Product Change Notification (Notification – P2212070-DI)			
(PA220009) December 1, 2022			
То:	Our Valued Distribution Customer		
Overview:	The purpose of this notification is to communicate a change to Renesas Electronics America, Inc. (REA) devices.		
	This notification announces an update to the standard interior labels for all shipments. See the Appendix for additional details.		
	There is no impact to part numbers, specifications, fit, form, characteristics, quality & reliability of the products.		
Affected Products: All Renesas Devices			
Key Dates:	Shipments using new labels for Legacy Intersil (REN-PWR), Legacy IDT (REN-ANLG) & Legacy Dialog (REN-DIA) product begins. Cross shipment of products with old and new labels may occur for a period of time.	Aug. 1, 2023	
	Shipments using new labels for Legacy Renesas (REN-EP) product begins. Cross shipment of products with old and new labels may occur for a period of time.	Apr. 1, 2024

Appendix A: Legacy Intersil (REN-PWR) Products

Appendix B: Legacy IDT (REN-ANALOG) Products

Appendix C: Legacy Dialog (REN-DIALOG) Products

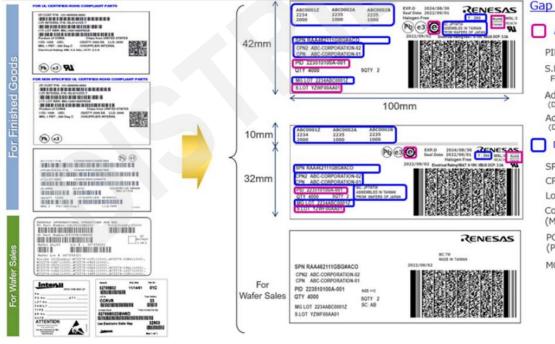
Gap Points Current and New / Ex-ISL

Added Items

PID (Traceability Control) S.LOT (Traceability Control)

Add RoHS / RoHS Exempt (Display RoHS or RoHS Exempt) Add China RoHS (Display China RoHS Certified)

Design Change Items

SPN (Orderable Parts No.) CPN/CPN2 (Customer Parts No.) Lot Combine Information Country of Origin (Manufacturing Country Info.) PCB On Board Reflow Rank (Peak Temperature) MG LOT (Manufacturing Lot No.)

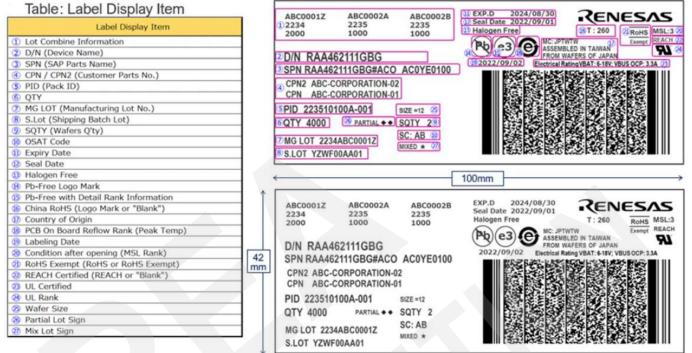
Gap Points Current and New / Ex-IDT

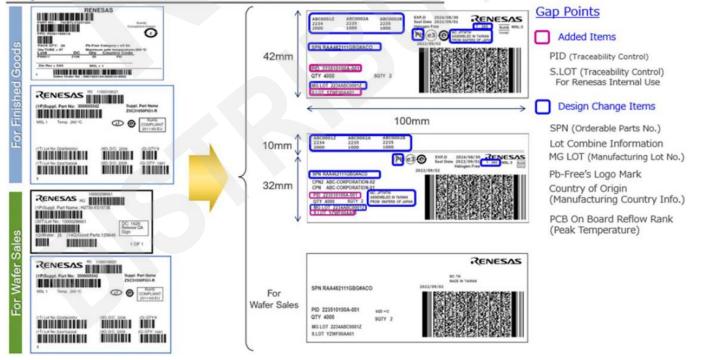
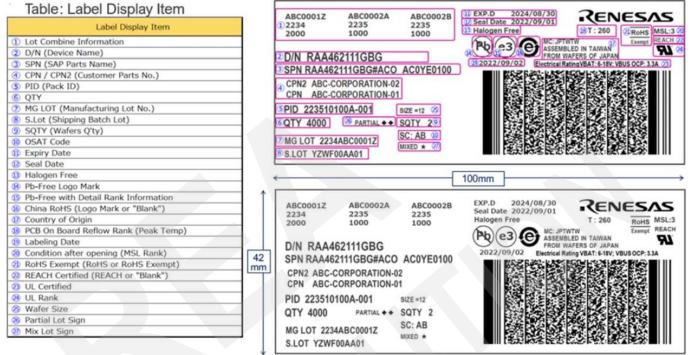
Gap Points Current and New / Ex-DLG

Appendix D: Legacy Renesas (REN-EP) Products

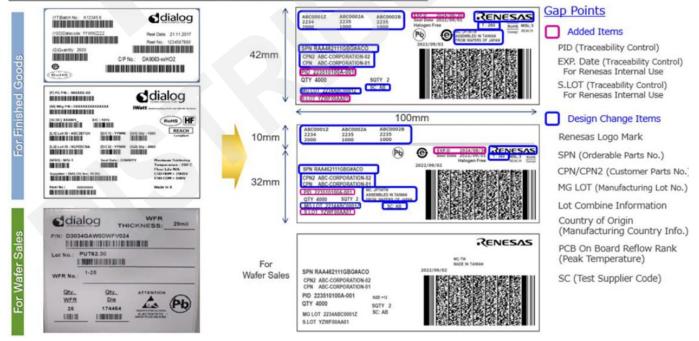
Gap Points Current and New / Renesas Japan (REL)
